Raymond A. Lieb
Vice President, Nuclear419-321-7676
Fax: 419-321-7582July 24, 2013
L-13-197

Davis-Besse Nuclear Power Station
Docket No. 50-346, License No. NPF-3
Response to Request for Additional Information on 10 CFR 50.55a Request RR-A37
(TAC No. MF0752)

Figure 1
1-2 RCS COLD LEG DRAIN NOZZLE
RC-40-CCA-18-3-FW9 OVERLAY
CIRCUMFERENTIAL COVERAGE

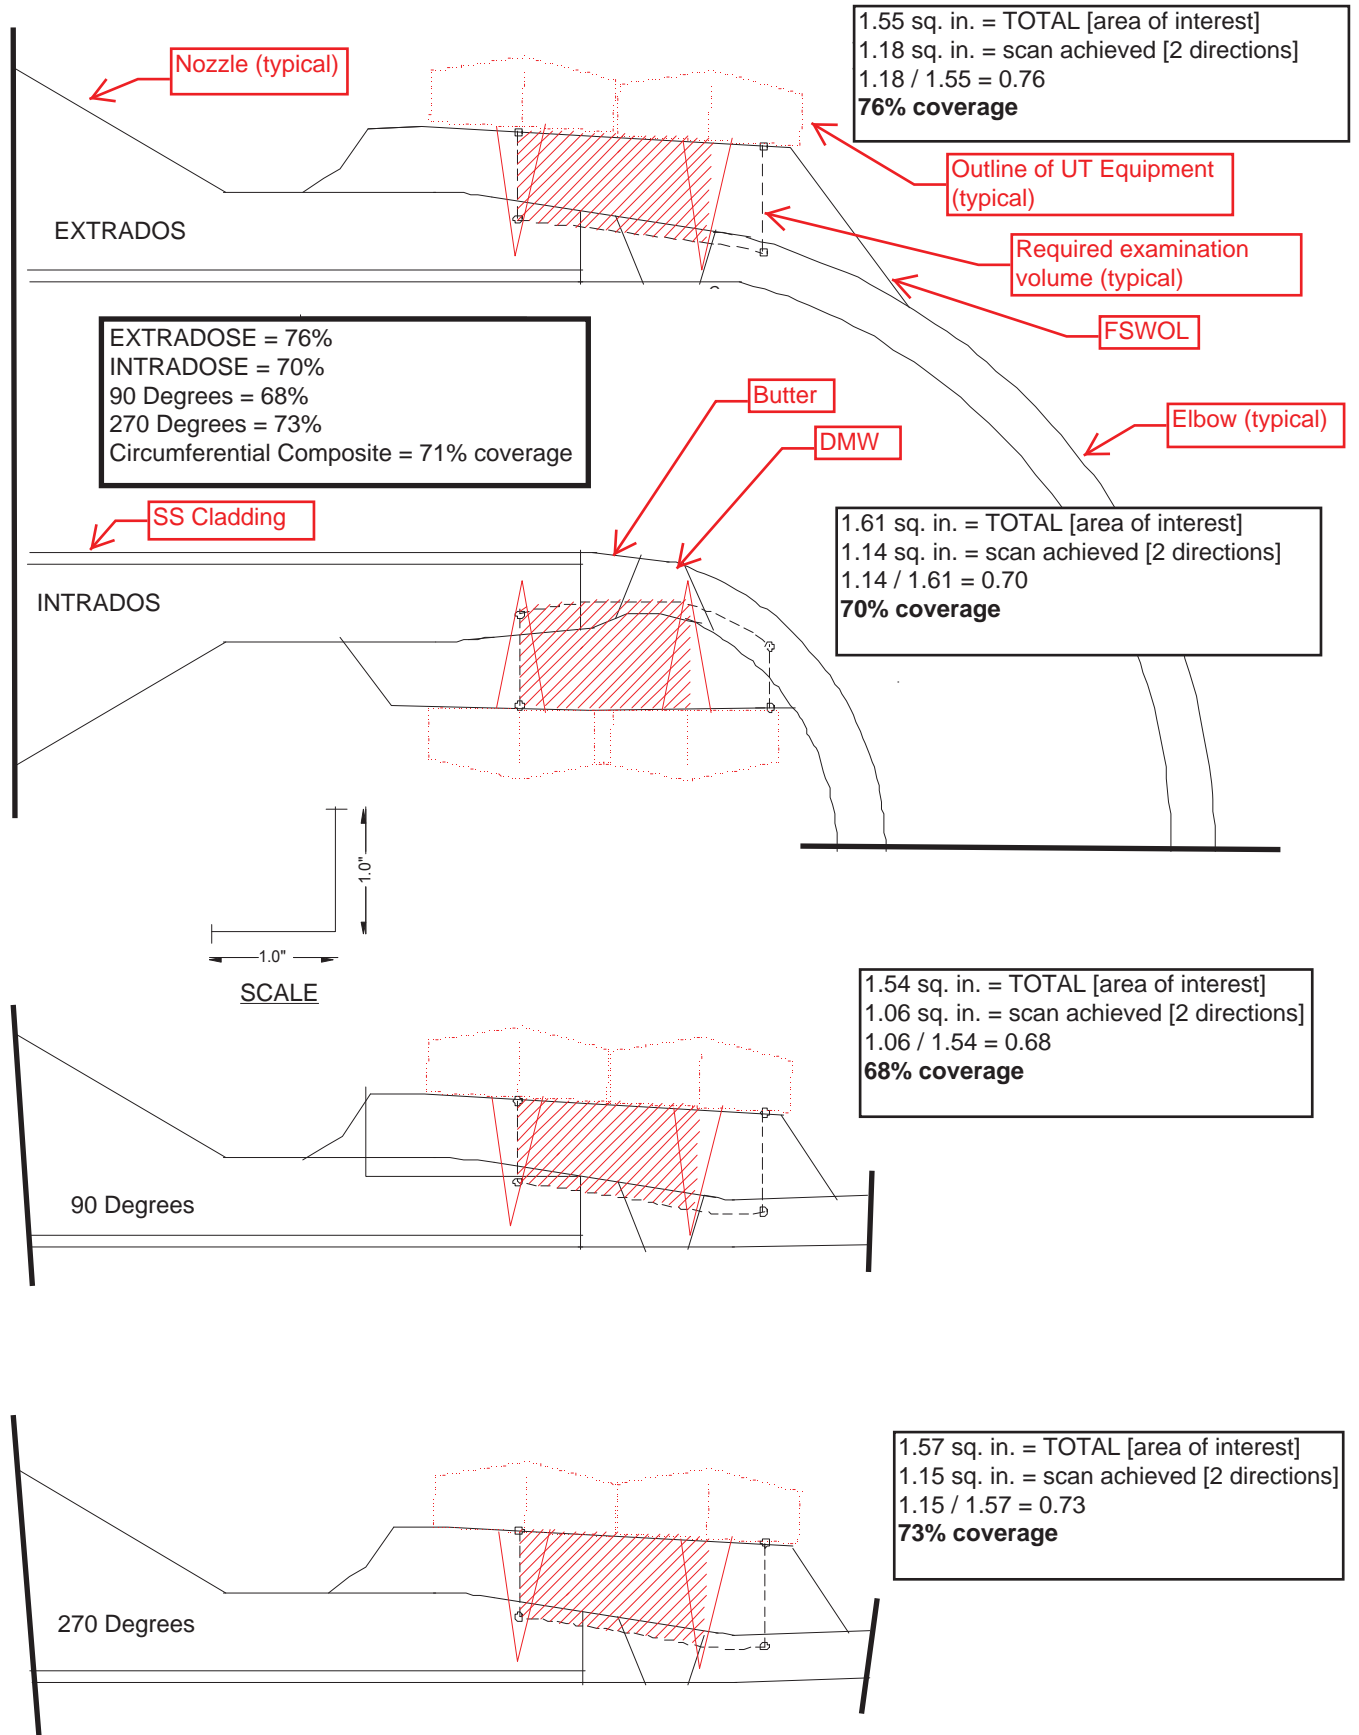
- 2. The NRC staff is unable to determine the exact volumes that were examined and the part of the required volume that was not examined from the drawings provided in the proposed alternative.**

Provide clear scale drawings (with scale indicated) of the subject DMBW [dissimilar metal butt weld], including weld butter and FSWOL [full structural weld overlay] indicated. Clearly show the American Society of Mechanical Engineers (ASME) Boiler and Pressure Vessel Code (Code) Case N-770-1 required examination volume and the volume of material interrogated by the examination in the axial and circumferential scan directions.

The requested information is provided in Figures 1 and 2.

Figure 3
1-2 RCS COLD LEG DRAIN NOZZLE
RC-40-CCA-18-3-FW9 OVERLAY
CIRCUMFERENTIAL COVERAGE

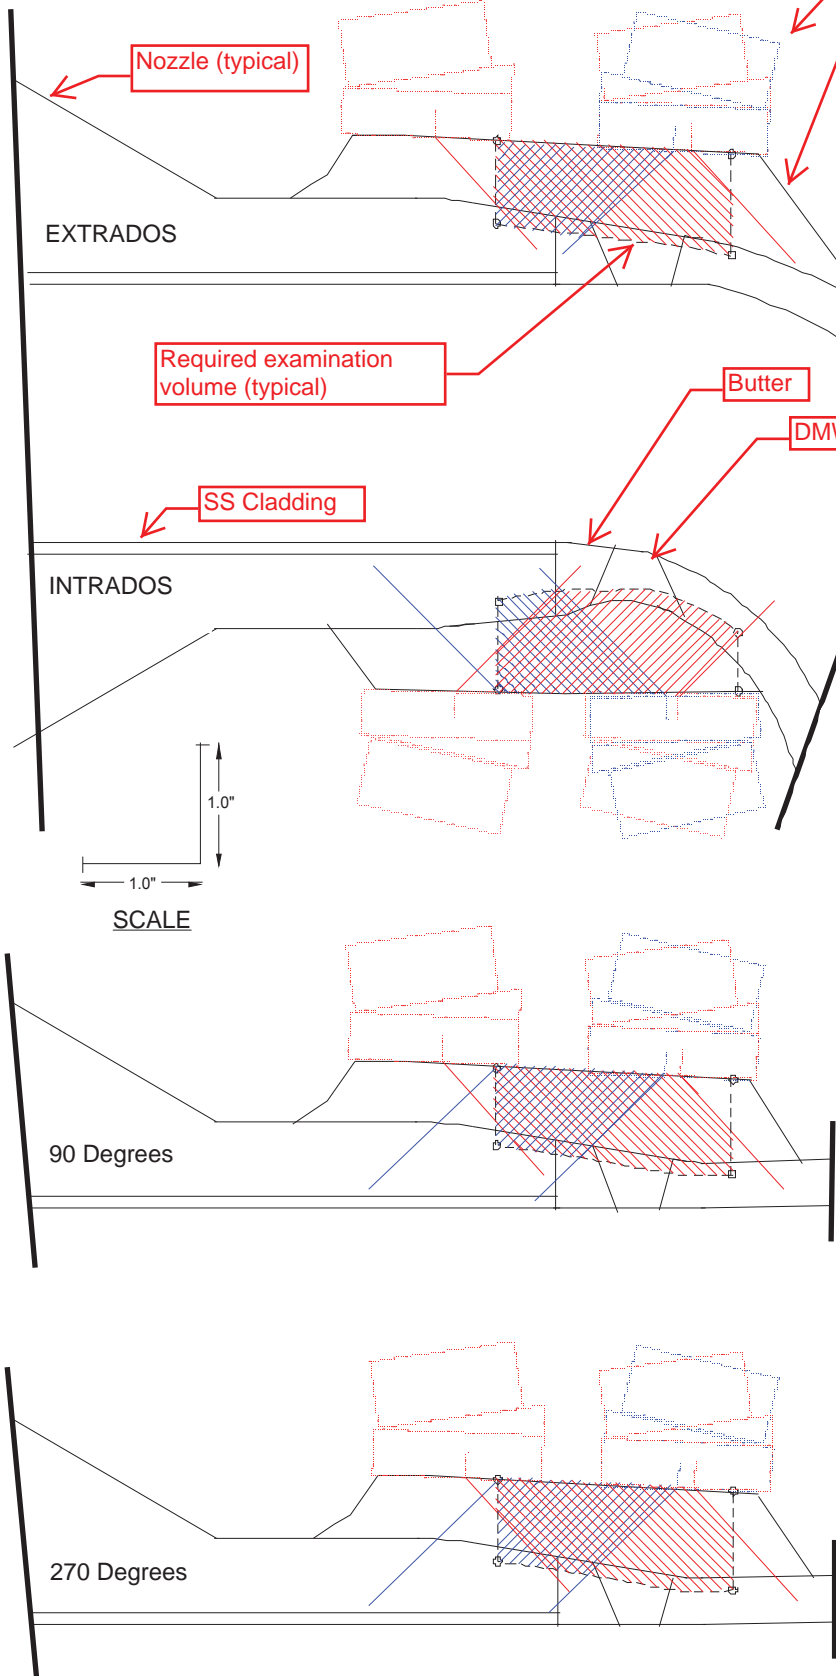
- 3. Provide a table detailing the scan coverage achieved for each of the following:**
- a. carbon steel nozzle;**
 - b. stainless steel elbow;**
 - c. susceptible weld metal; and**
 - d. full structural weld overlay.**

Provide values for scans in the circumferential and axial directions.

The requested information is provided in Figures 3 and 4 with coverage values expressed as percentages.
